STAFF MEMO

Date: October 11, 2021
To: Town of Milford Planning Board
From: Jason Cleghorn, Town Planner
Subject: **SP2021-04 Crosby Townhomes, Kling/Mengyuan Property Management, 159 Elm Street, Map 19, Lot 5.** Public Hearing for a major site plan application to construct a six (6) unit townhouse, multi-family residential project with related parking, drainage/stormwater management, landscaping, and lighting improvements.

Re: **Crosby Townhouses**
Site Permit
RMI Response Letter #1
Tax Map 19 Lots 5

TYPICAL APPLICATION TWO WAY TRAFFIC LANE SHIFT

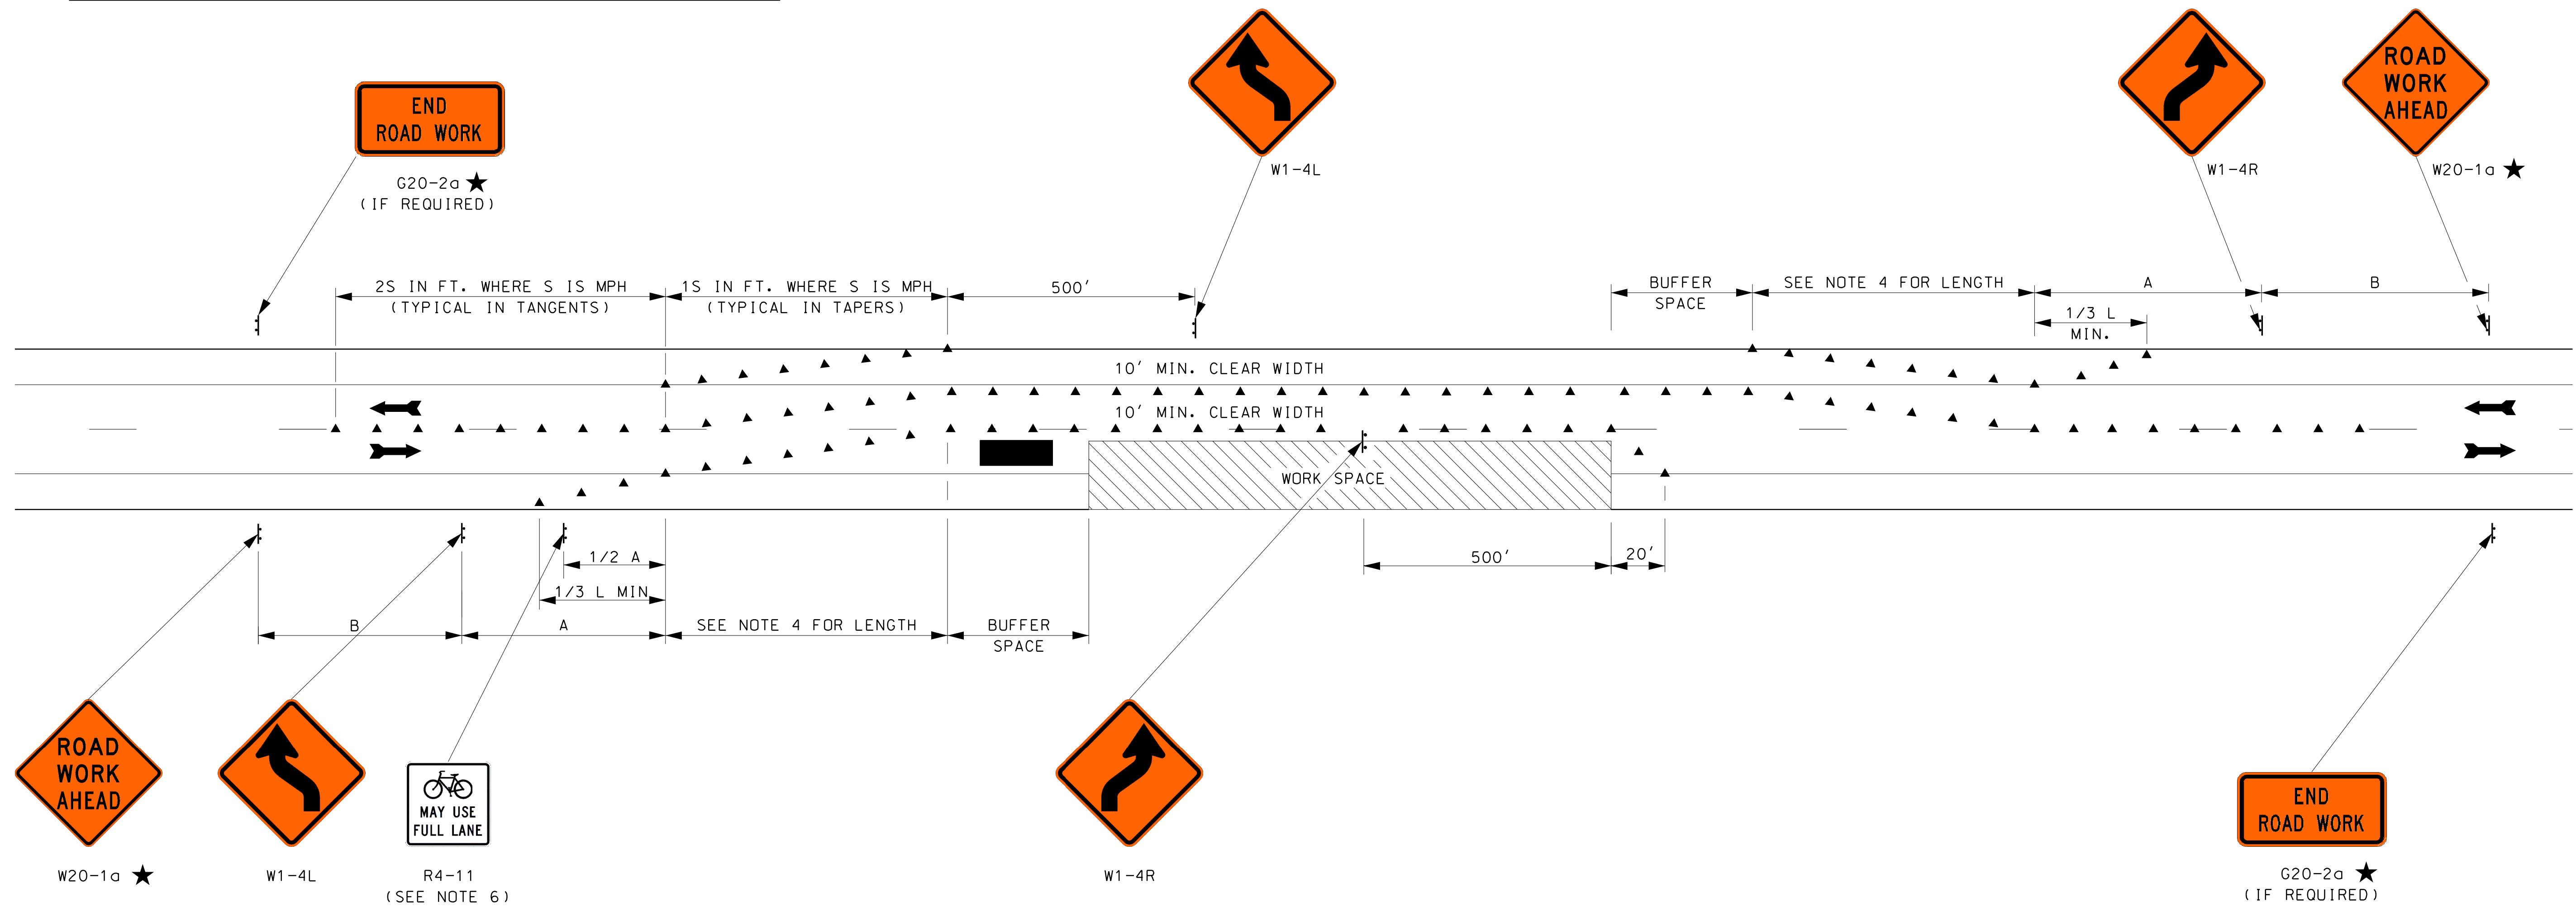
1. Informational comment: When water and sewer work is done, a police detail will be needed for traffic control (maintenance of traffic)

A Work Zone Traffic Control Plan that meets State Standards has been attached with this submittal. This plan involves a lane shift on a two-lane road for any work to be performed within or adjacent to the travel lane.
